**CITY OF TEMPE
DEVELOPMENT REVIEW COMMISSION**

Meeting Date: 02/23/2016
Agenda Item: 5

ACTION: Request for an Amended Planned Area Development Overlay and a Development Plan Review for a 13-story mixed-use development, containing 281 dwelling units and 1,641 s.f of retail for LOT 1 @ FARMER ARTS DISTRICT – PARCEL 1, located at 707 South Farmer Avenue. The applicant is Charles Huellmantel of, Huellmantel and Affiliates.

BACKGROUND INFORMATION: LOT 1 @ FARMER ARTS DISTRICT- PARCEL 1 (PL150526) is a proposed mixed-use development, 13-stories consisting of residential, ground level retail and garage parking. **Note: This project is part of an approved development agreement. This site is required to provide underground parking and a streetscape design consistent with other Farmer Arts District projects.** The request includes the following:

1 SITE PLAN - DPR
A1.00 | 1" = 20'-0"

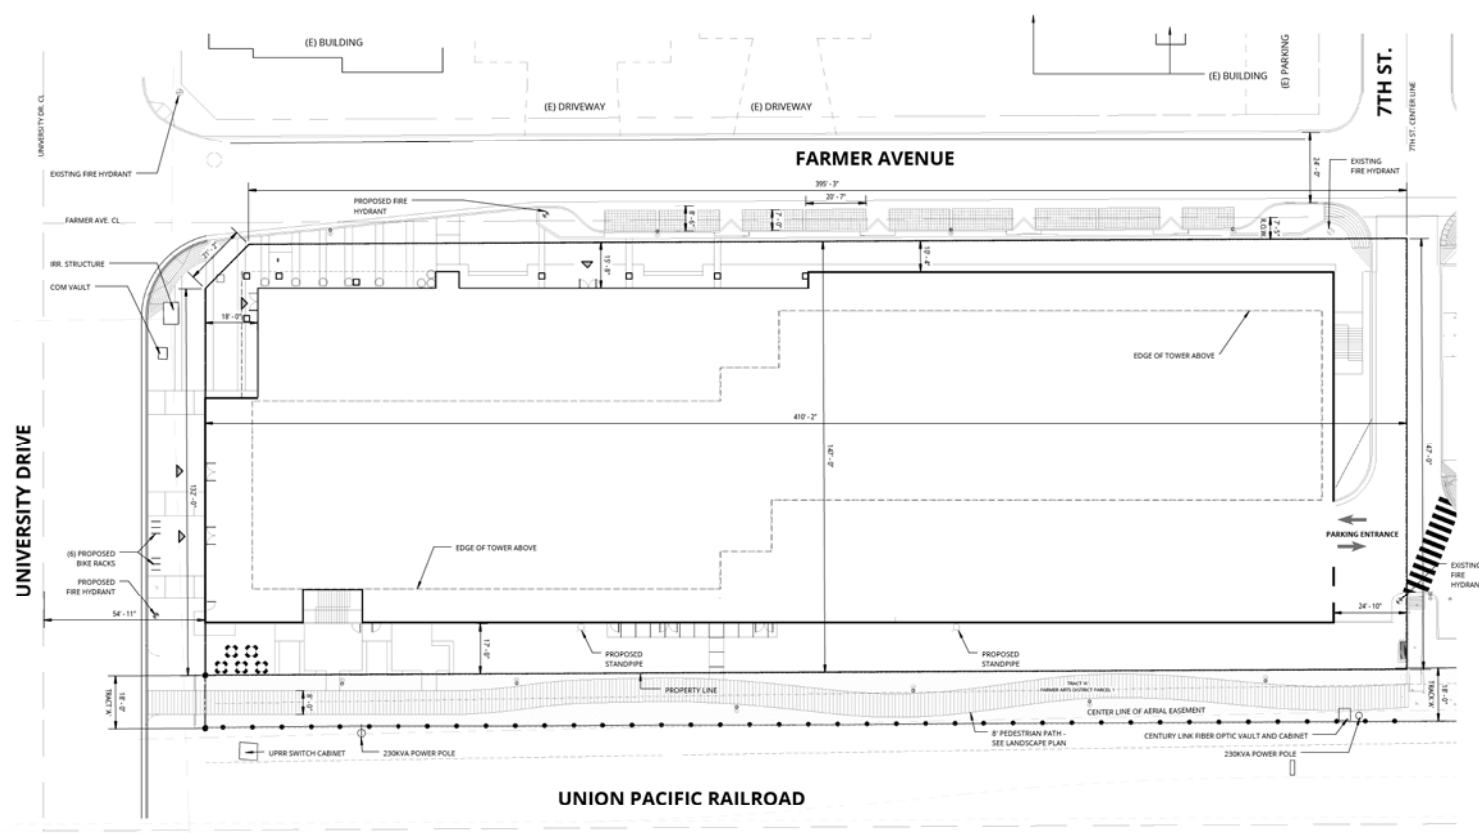
3. Work with utility providers for irrigation structure and communication vault to consider decorative materials that are complimentary to those proposed for the development where equipment is identified on the site plan.

5. A bi-directional ADA ramp, following the T-328 detail, shall be provided on the northeast corner of Farmer Avenue and University Drive. Approval is subject to final review by the Public Works Department, Transportation Division.

6. No more than 40% of the ground floor building length along Farmer Avenue or University Drive shall be parking structure façade. Coordinate on building elevations and floor plans.

3 EAST ELEVATION - B&W
 A3.00 | 1" = 20'-0"

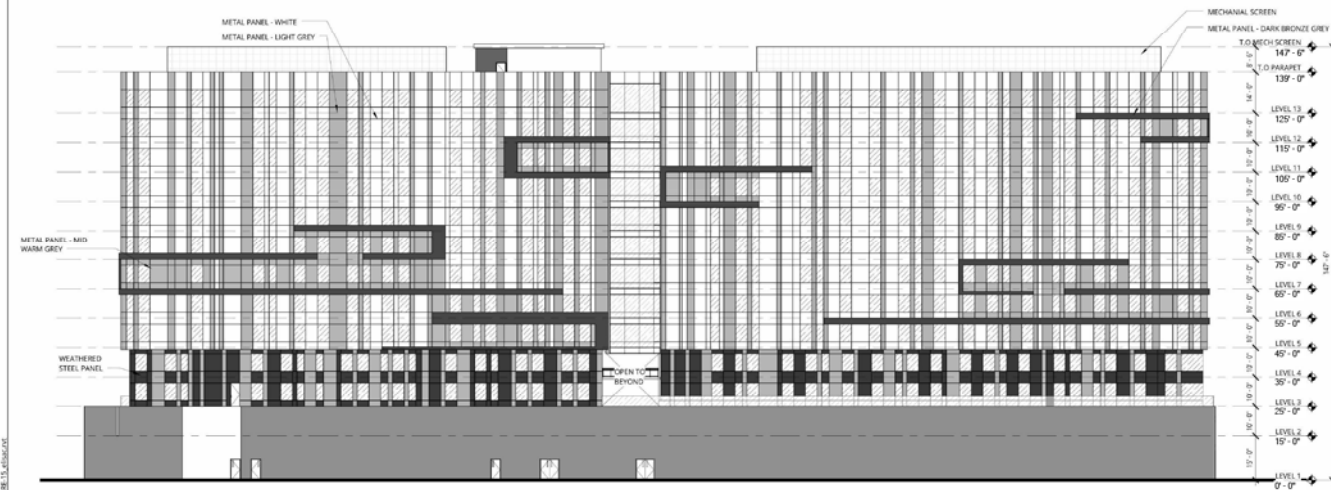
The first 25' of east elevation is proposed as only being masonry. A condition has been added that more architectural articulation be provided for that portion of the building to provide a better pedestrian level experience. Also the first 3' of the two parking garage levels facing Farmer Avenue are called out as being masonry but is not made clear on the elevation; so a condition has been added that the first 3' of each level be screen by a 100% opaque material.

18. Perforated metal shall be integrated with horizontal slots, to be consistent with other design and architectural features of building.
19. For first 25' of building height from grade for the entire building length of east elevation, provide more architectural articulation; this can be accomplished by incorporating other materials proposed for building or changes in horizontal and/or vertical planes.

20. First 3' of each above grade garage levels shall be screen with a 100% opaque material.
21. Above grade amenity deck adjacent to a public street shall provide a minimum 6'-0" barrier, measured from floor grade, with at minimum the top 2'-0" designed with glazing. Landscape planters shall be located on either the exterior or interior of the wall to act as a buffer from the building edge.

1 ENLARGED WASTE/REFUSE PLAN
A1.03 | 1/8" = 1'-0"

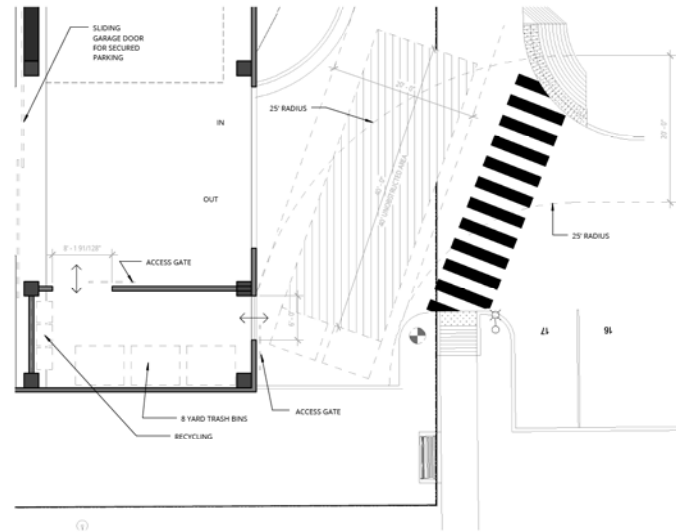
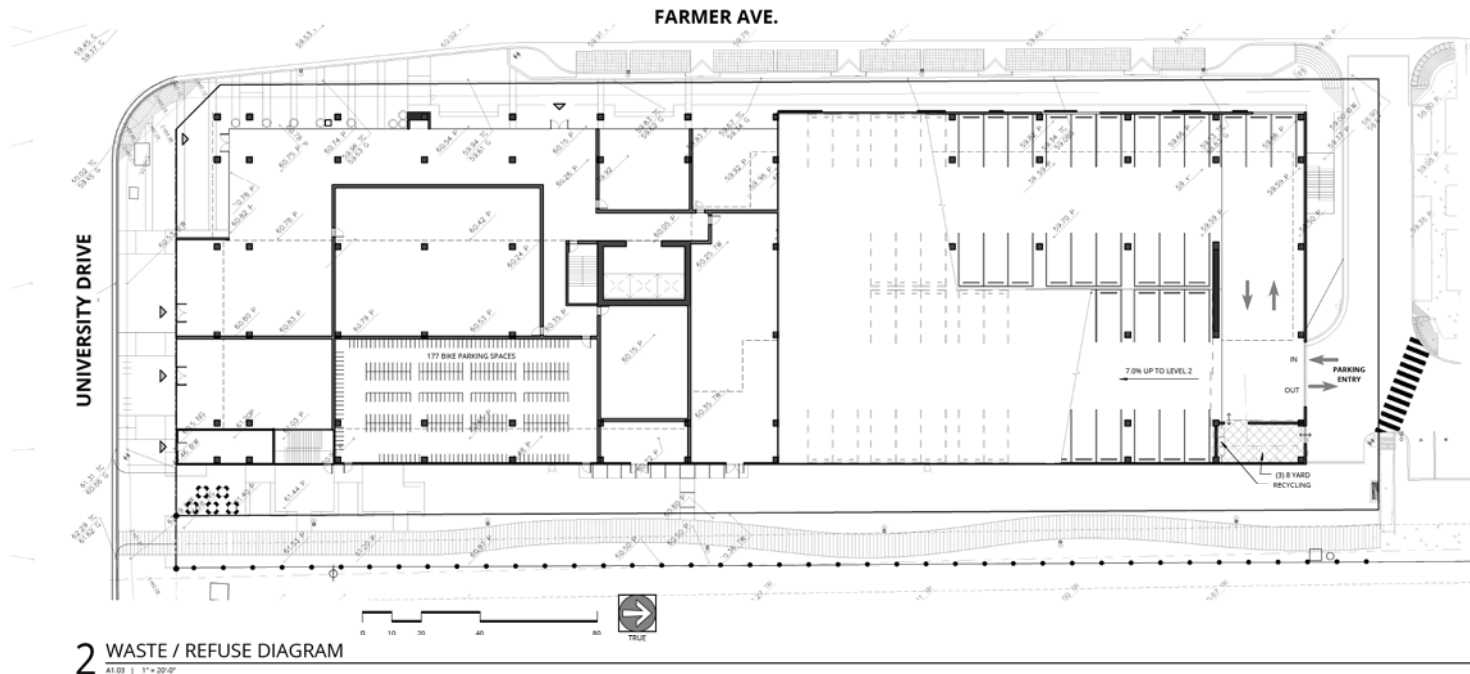
8. Location for refuse and recycling pick-up on property shall be modified to provide 45' of unobstructed straight-line backing for service. Coordinate the collection and pick-up areas for refuse and recycling containers with the overall site and landscape layout. Approval is subject to final review by the Public Works Department, Solid Waste Division.
